TECHNICAL BULLETIN INDEX
Sorted by Bulletin Number
04/03/86

BULLETIN NO: II:1

PRODUCT: 26-4001/2 Model II

Figure 1

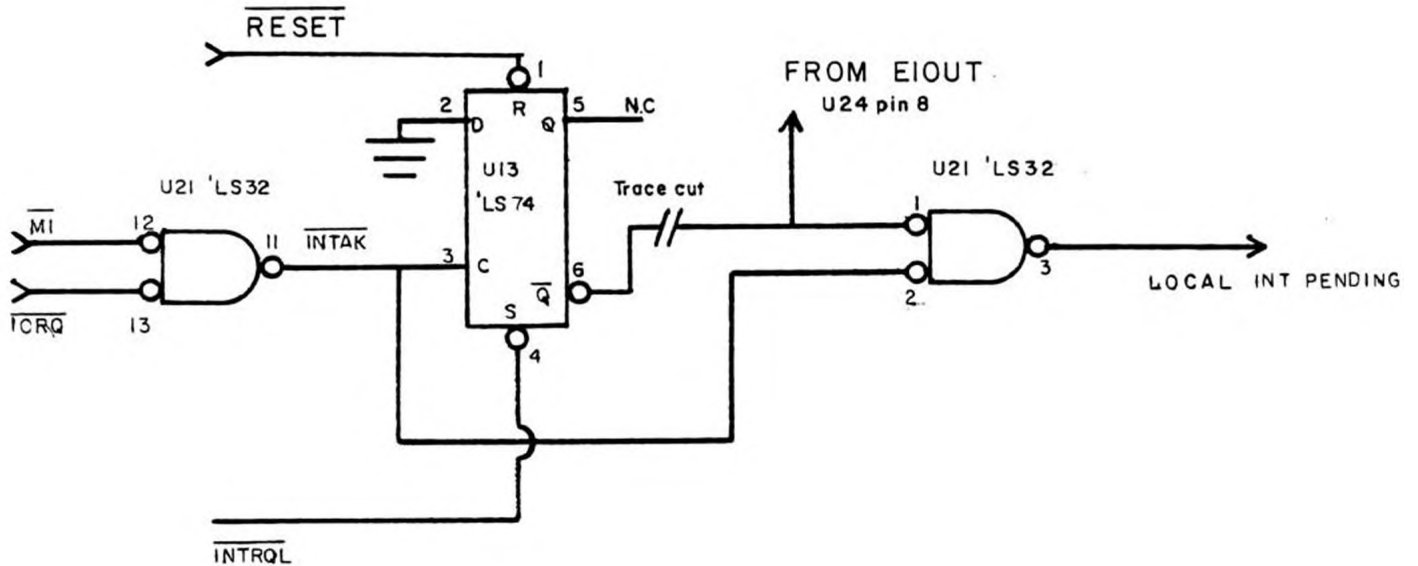
Refer to Figure 1 for schematic changes affected by this modification. The signal Local Interrupt Pending is now ANDed with EIOUT, and not with INTRQL. Previously, if the SIO programming was changed with interrupts disabled, a local interrupt could set flip-flop U13 without being serviced. Later, when an off board interrupt occurred, the bus steering logic would mistakenly interpret this as an on-board interrupt and would not turn the external data receive buffers. By ANDing the EIOUT signal with INTAK signal this problem is eliminated.

If the CPU board is a Rev A/B/C or no Rev letter, cut the trace on the back of the board between U13 pin 6 and U21 pin 1 and add a jumper wire between U21 pin 1 and U24 pin 8. Rev D, later Rev boards, and boards that have been modified for hard disk require NO cuts or jumper wires. However, the push on jumpers must be changed on all boards.

Figure 1

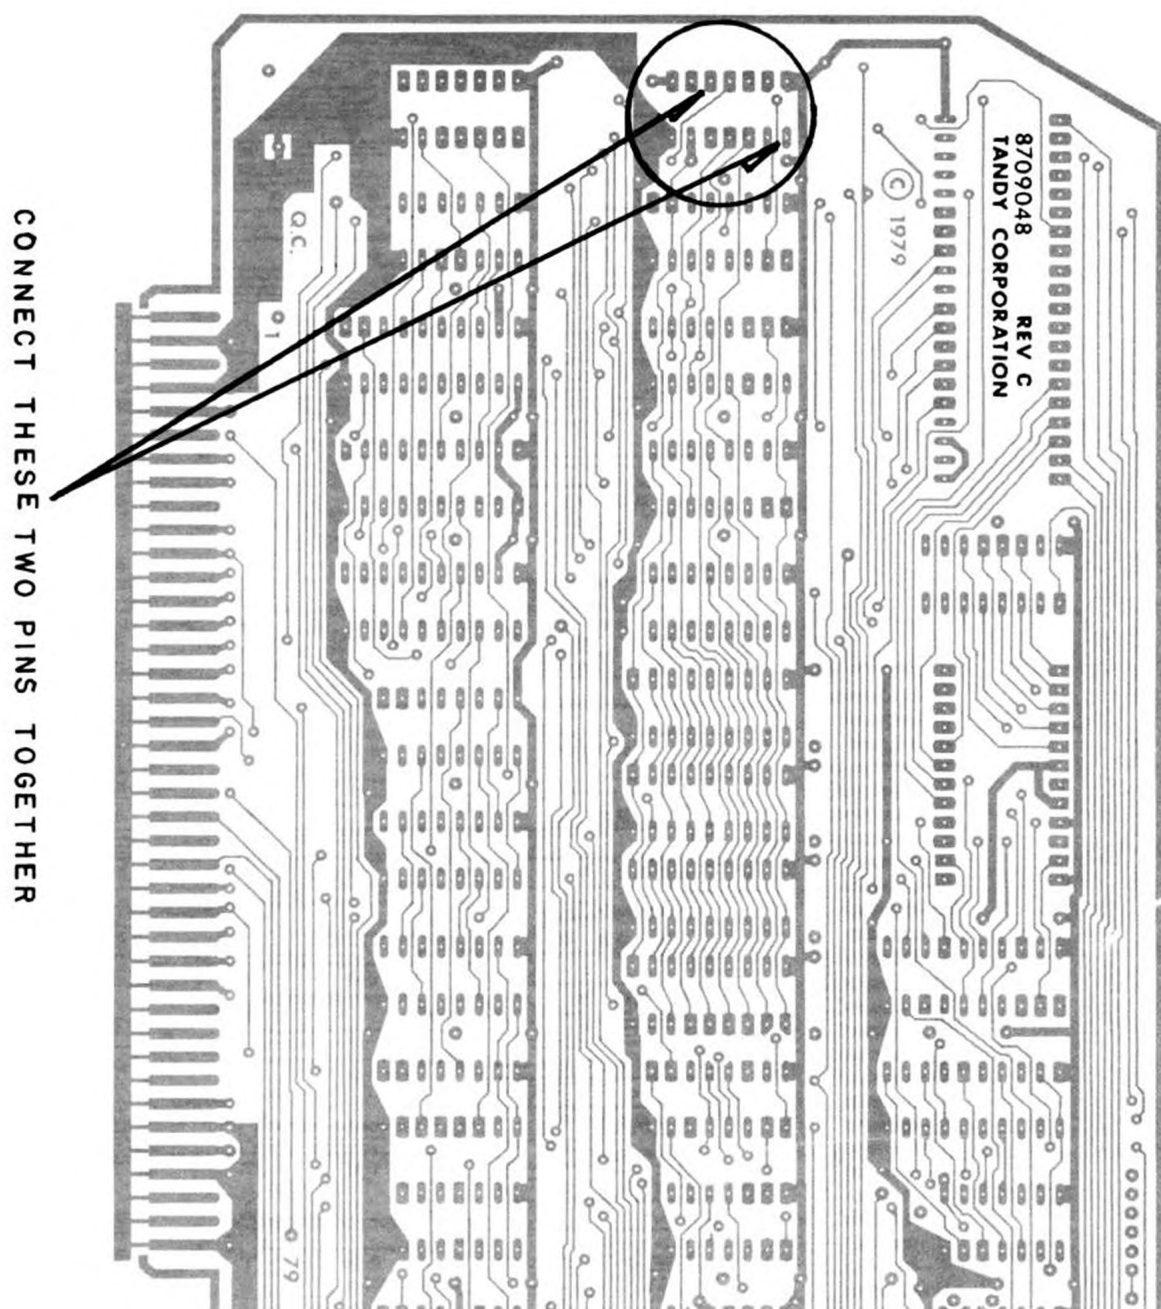
PURPOSE: To correct dual addressing on Video/Keyboard Interface boards (Rev A/B).

DISCUSSION: Rev A and B VDG boards have a problem with dual addressing. Addresses FC through FF are decoded on the VDG board for use by the Model II. There is an image of these addresses from 7C through 7F. Most systems will not have hardware port mapped at these addresses so no problem will appear. The only time a problem may arise is if a system has hardware installed that is port mapped in the range of 7C through 7F. This problem was corrected on Rev C VDG boards.

PROCEDURE: Whenever a Rev C VDG board is replaced with a Rev A or B VDG board jumper pin 1 to pin 10 of U27 on the Rev A or B board to insure no addressing conflict of the VDG board (Refer to Figure 1).

FIG 2

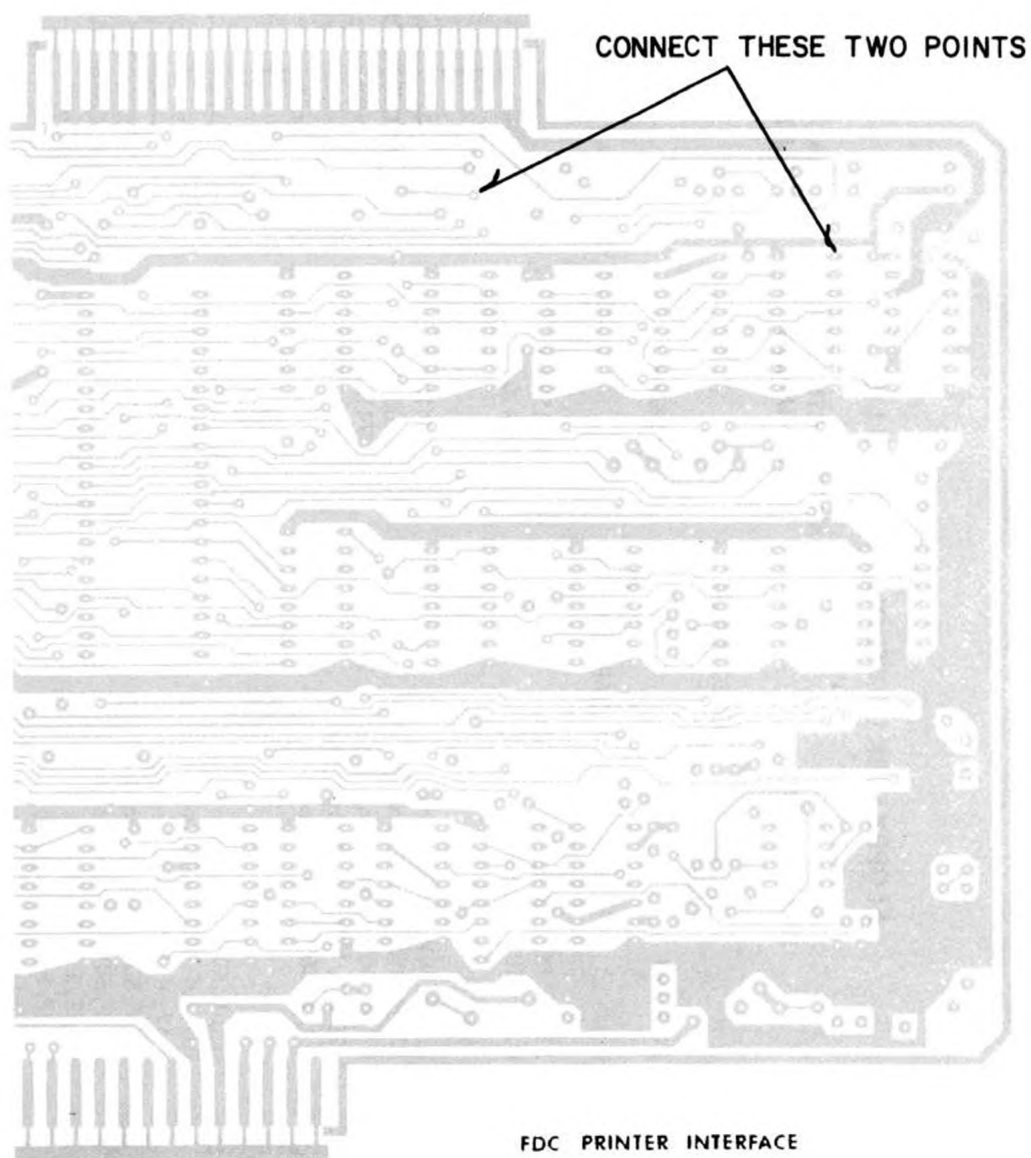
PURPOSE: To correct problem of not being able to format past Track 43.

DISCUSSION: Some early FDC boards may not be able to format past Track 43 with precomp set at the required specification of 250 nsec. This problem will occur ONLY with the SY1791-02 FDC chip (not the FD1791-02 FDC chip) because the EARLY pulse ends slightly sooner on the SY1791-02. This could lead to a double pulse being picked off the shift register. To correct this problem the data out is tied to the RESET of the shift register. As soon as the data triggers the one-shot, it then clears the shift register, preventing double data pulses (Refer to Figure 1).

PROCEDURE: On unmarked, Rev A, or Rev B boards make sure the "one shot" modification has been installed (Refer to Technical Bulletin II:9), or that long jumpers are installed on the back of the board running to U37. Disregard this step on Rev C and D boards as they have this modification incorporated into their circuitry. On ALL revisions of the current board with a SY1791-02 FDC chip installed, add a jumper wire on the back side of the board from U1 pin 1 to the trace connected to TP 10 (Refer to Figure 2).

Figure 1

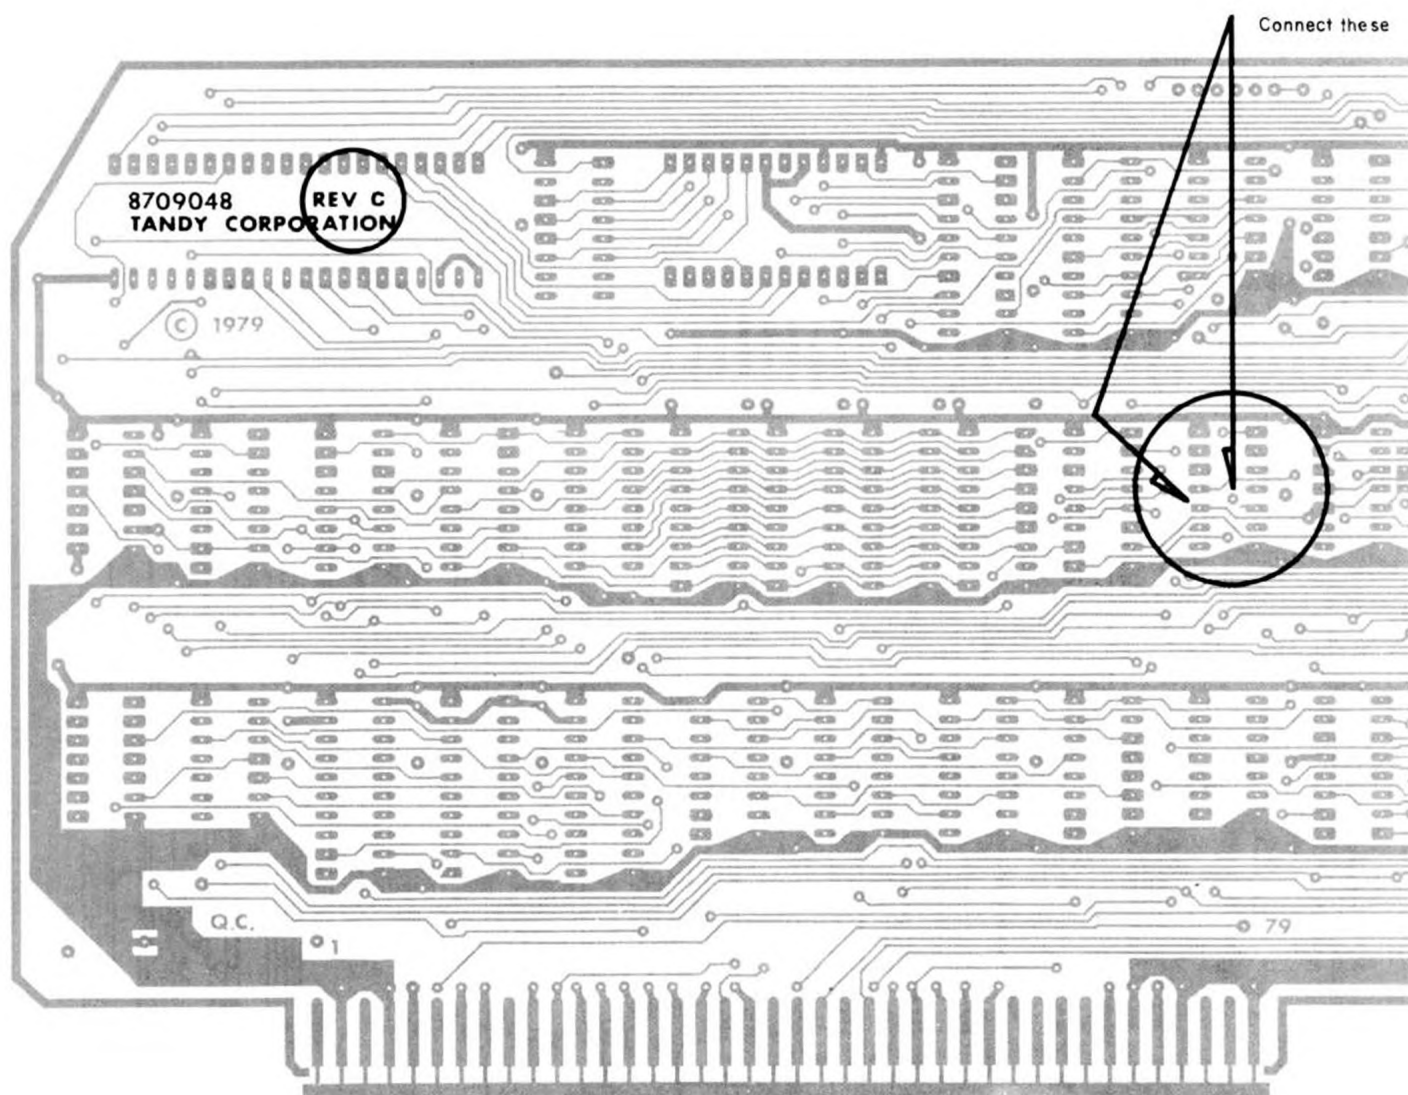
PURPOSE: To correct unexplained keyboard entries and/or machine lockup.

DISCUSSION: On Rev C VDG boards made by Lika there is a trace missing to the clear line on the latch (U17) that generates KBIRQ*. This can generate random interrupts that may or may not be fatal. To correct this problem a jumper is added to correct the missing trace which is a pullup to the clear line of U17. To identify the board as being manufactured by Lika, look for the Rev C marking on the solder side of the board under the 6845 chip and by LEI etched also on the solder side the crystal. This is the ONLY board to which this fix applies.

PROCEDURE: On the solder side of the board there is a feedthru located beneath the middle of U17 that is not connected to anything. Run a short piece of wire from that feedthru to U17 Pin 10 (Refer to Figure 1).

Figure 1

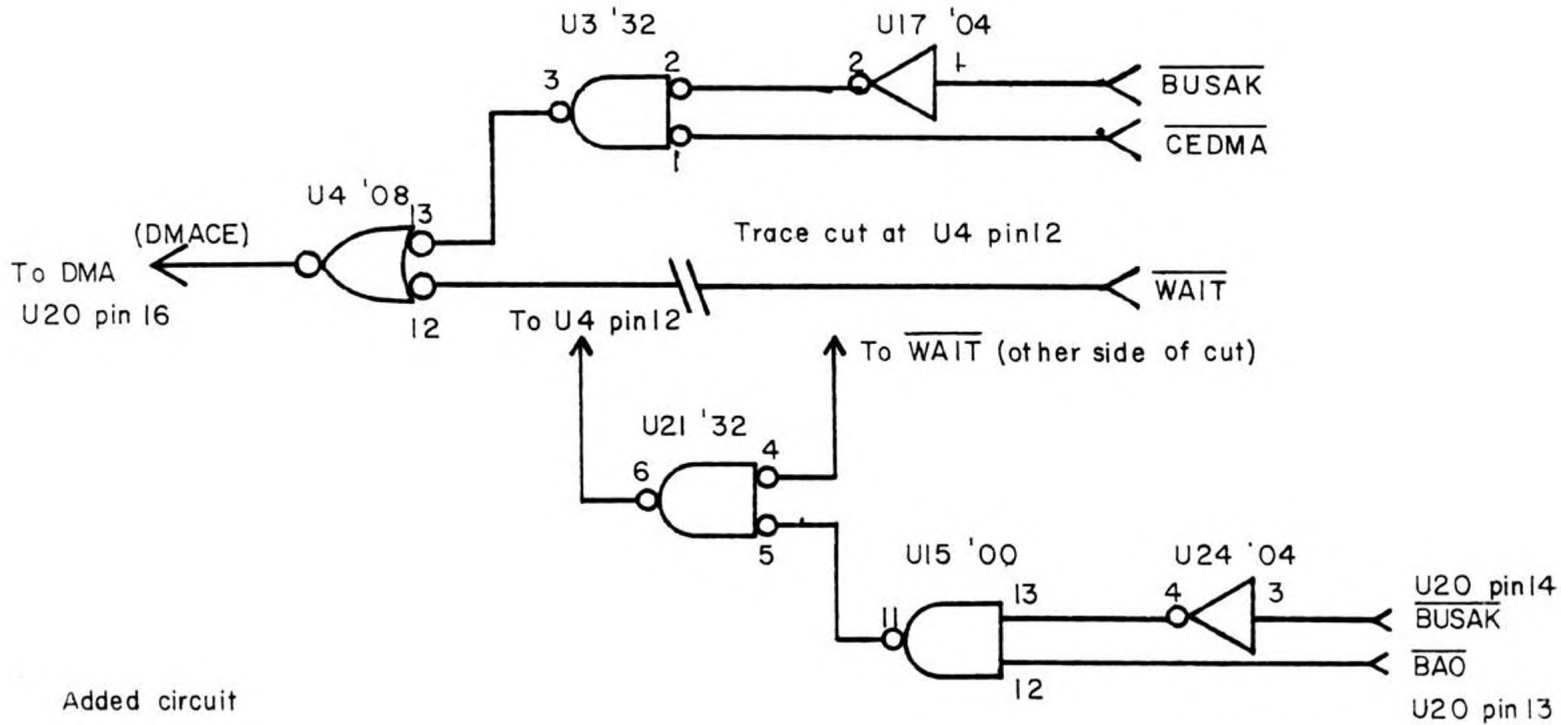
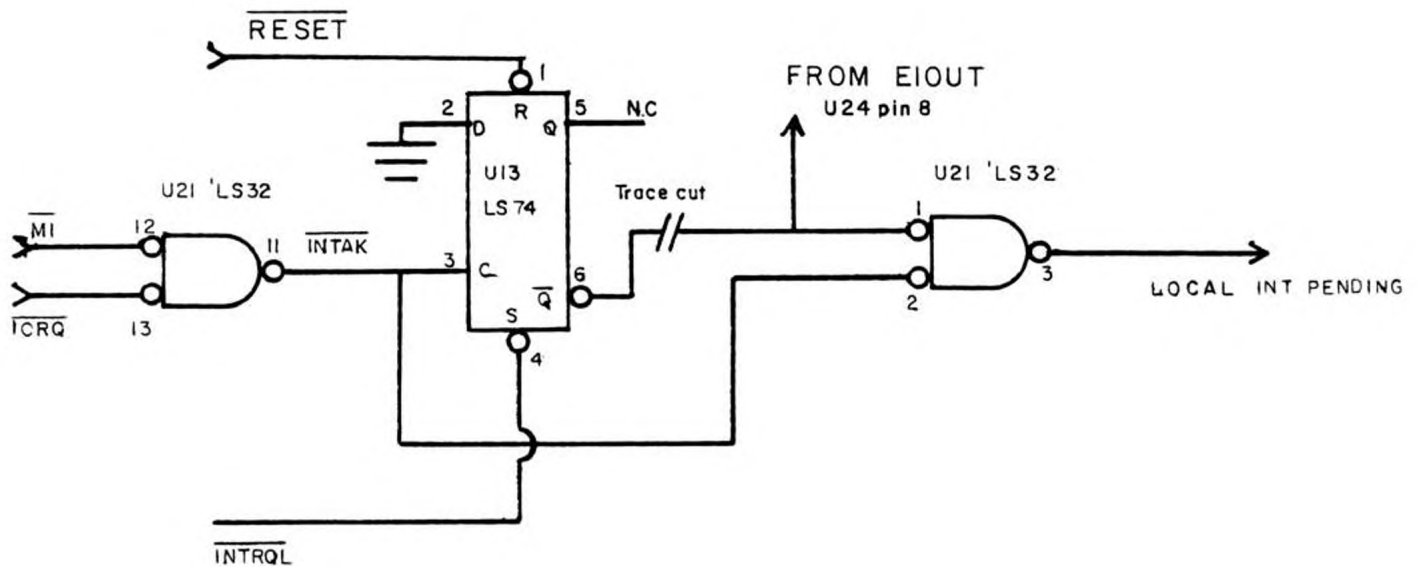
DISCUSSION: This modification is the same as the Hard Disk modification except it does not include anything unique to the Hard Disk such as the Boot ROM. Rev A,B, and C boards are the ONLY CPU boards to which this modification applies. DO NOT perform this modification on Rev D and later boards as they have this modification incorporated into their design. Refer to Figures 1 and 2 for schematic changes affected by this modification.

U21 pin1 to U24 pin8
U4 pin12 to U21 pin6
U21 pin 4 to WAIT* (the first feedthru after the cut at U4 pin 12)
U21 pin5 to U15 pin11
U15 pin12 to U20 pin13
U15 pin13 to U24 pin4
U24 pin3 to U20 pin14

Figure 1

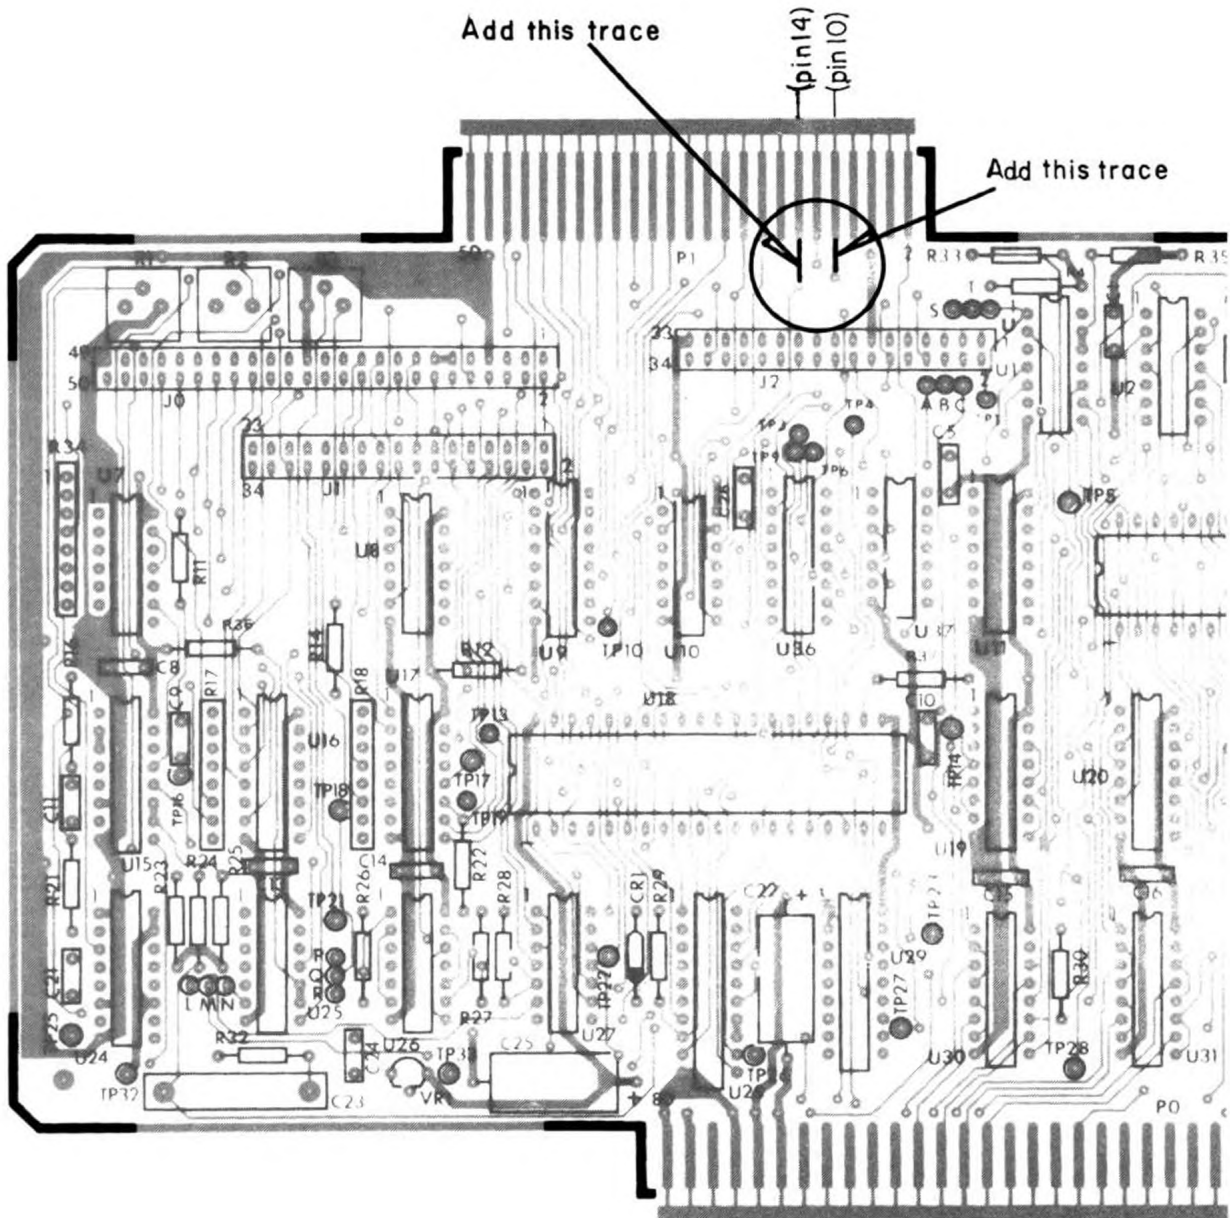
DISCUSSION: The trace that supplies the side select signal to the external drive connector on the Late Design FDC board (Rev Blank) is missing. Also, on some boards the trace that supplies the TWOSIDE* signal from the external drives to the FDC board is not present. Without these traces double sided drives cannot be used externally with the computer and will cause a problem with some diagnostics.

PROCEDURE: Refer to Figure 1 for the location of these traces. Run a jumper from pin 14 of connector PI to the feedthru on the PCB that is directly in from the connector. Also run a jumper from pin 10 of connector PI to the feedthru that is directly in from the connector.
